From: Taxiarchou, John G <John.Taxiarchou@chevron.com>
Sent: Tuesday, October 21, 2014 12:56 PM
To: Kautz, Paul, EMNRD; Sonnemaker, William, EMNRD
Cc: Chandran, Prasanna; Bielenda, Robert F.
Subject: CH Weir A #20 Wellbore
Attachments: CH Weir A #20.pdf

Chevron U.S.A. Inc. Wellbore Diagram : WEIRCHA20

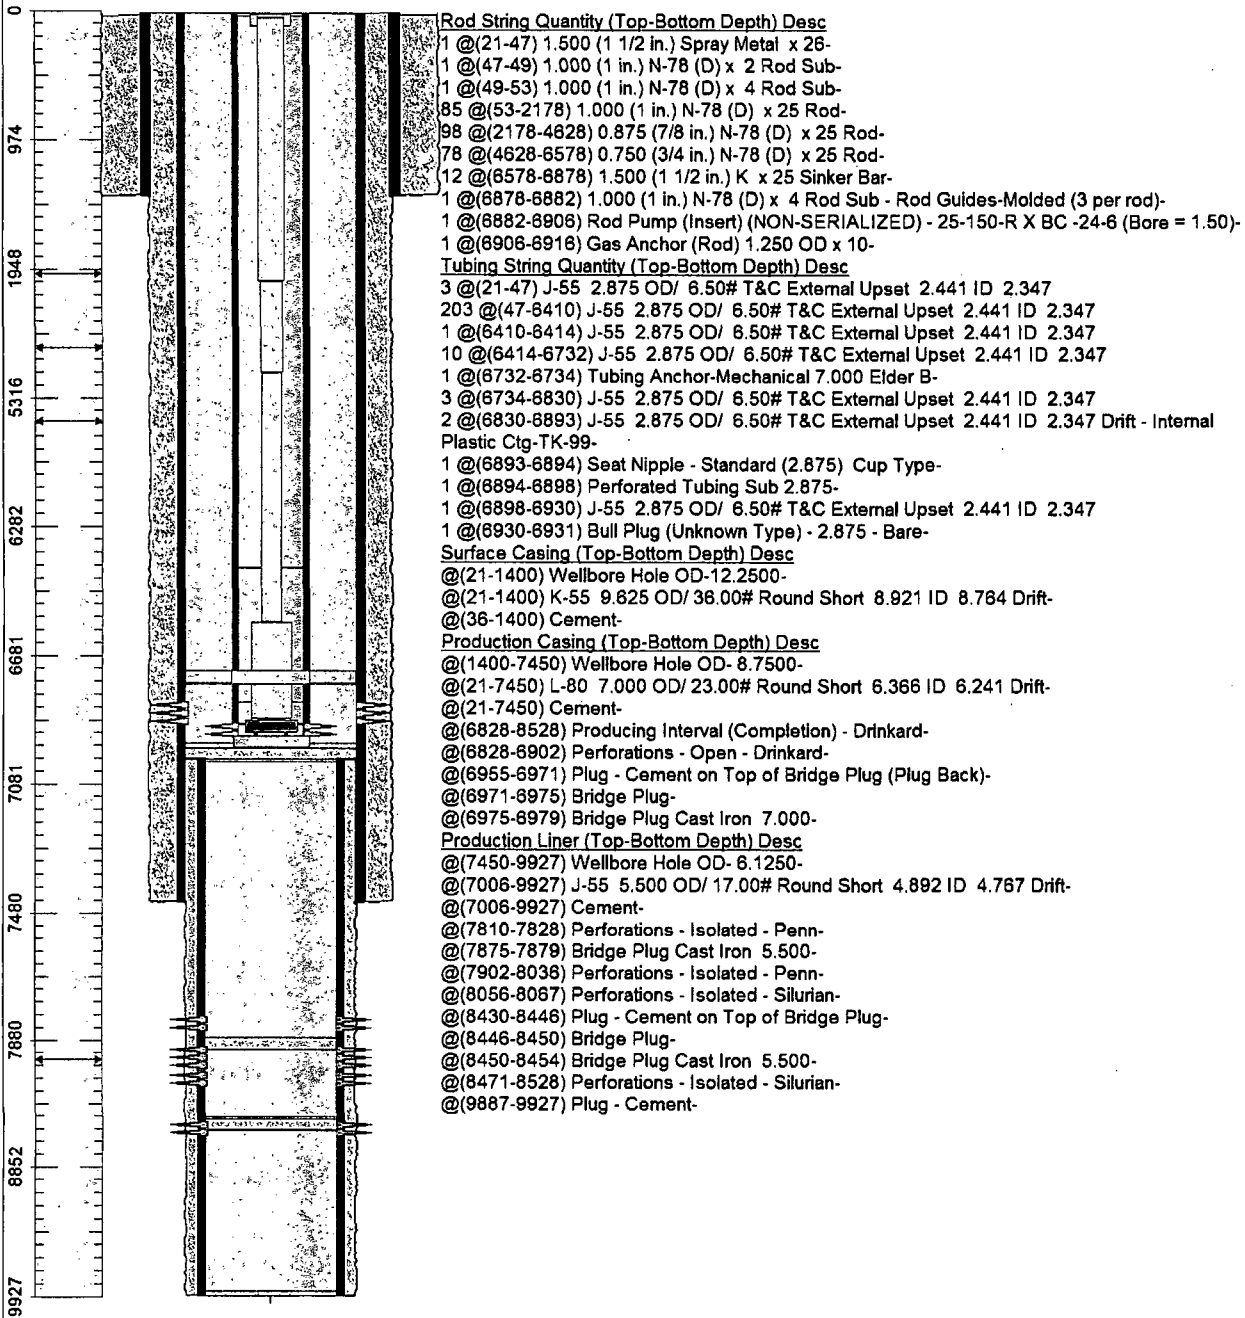
Paul/ Bill – Could you look at the CH Weir A #20 wellbore diagram. We plan on drilling out the 7" CIBP and adding perfs in the Drinkard above the 5.5" liner. While doing this we would like to plug back this well for P&A in the future.

The issue looking into this wellbore is that the CIBP on top of the Silurian formation has 16 ft of CMT on top.

We would like to propose to add 35ft of cmt on the CIBP 7875' and and another CIBP at 7790' with 35" of cmt, and not have to drill out the CIBP at 7875' to add cmt to the bottom plug.
